February 8, 2013

Doug Anderson
ENERGY STAR Home Improvement Program
U.S. Environmental Protection Agency
1200 Pennsylvania Avenue, NW
Washington, DC 20460-0001

Subject: ENERGY STAR Program Requirements for Residential Windows, Doors, and Skylights – Version 6.0 Draft 2 Eligibility Criteria

EPA Figure 1 – Draft 1 CAR, Pg. 8

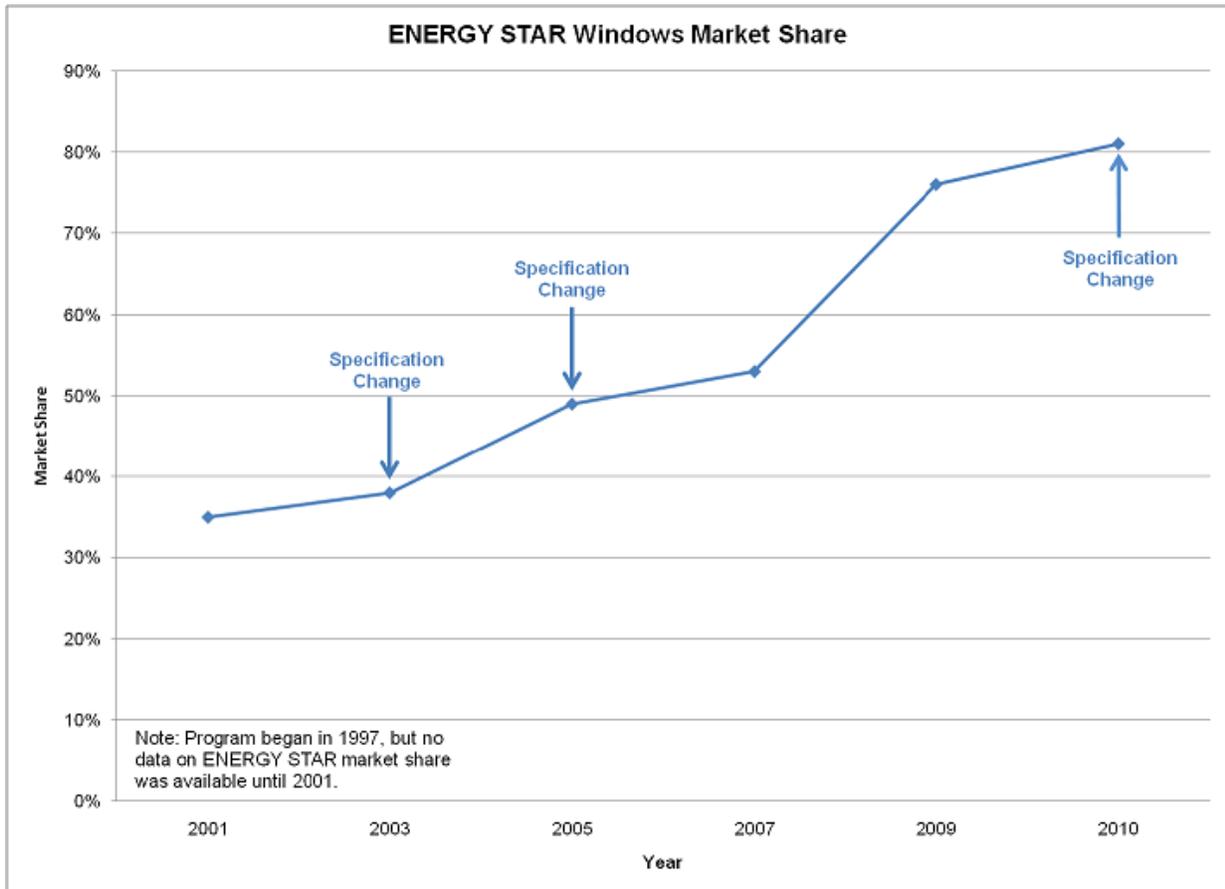
In Figure 1 of the Draft 1 CAR, EPA provides data on the market share for ENERGY STAR windows from 2000 to 2010. On its face, this figure appears compelling and unambiguous, with market share steadily increasing over time, from about 35 percent in 2001 to slightly over 80 percent in 2010. EPA draws the following conclusion from the market share trajectory:

JELD-WEN's figure provides essential additional information by revealing the market dynamics at work over this period. As JELD-WEN explained in its comments, "while the market of ENERGY STAR qualified windows has increased since 2006, the number of ENERGY STAR windows sold has declined." In fact, JELD-WEN's figure clearly shows that from 2005 to 2009, the overall market for windows declined by 44 percent, and the market for ENERGY STAR windows declined by 29 percent.

On EPA's figure, this period is depicted as a sharp increase in market share, which EPA attributes to innovation and/or cost-effectiveness improvements. On JELD-WEN's figure, it is clear that far fewer windows of all types were purchased and that 10 million fewer ENERGY STAR windows were purchased in 2009 as compared to 2005. Note that this sustained drop was not the immediate result of the ENERGY STAR specification revision of 2005. Instead, it is best explained as a result of the overall decline in the housing market due to a poor economy.

Based on the market share data presented by EPA in the CAR, it appears that the Agency is convinced that the ENERGY STAR market share will remain at about 80 percent as the window market expands if the specification is not revised. WDMA's concern is that EPA has repeatedly side-stepped the implications of the recent market decline on the validity of its conclusions. EPA has not presented the market share data in a way that makes it clear what was going on in the underlying windows market and the Agency has not seriously engaged in the content of the comments provided by stakeholders on these issues. Instead, it has focused solely on the market share trajectory laid out in Figure 1 of the Draft 1 CAR without regard or response to other significant market factors brought to the Agency's attention.
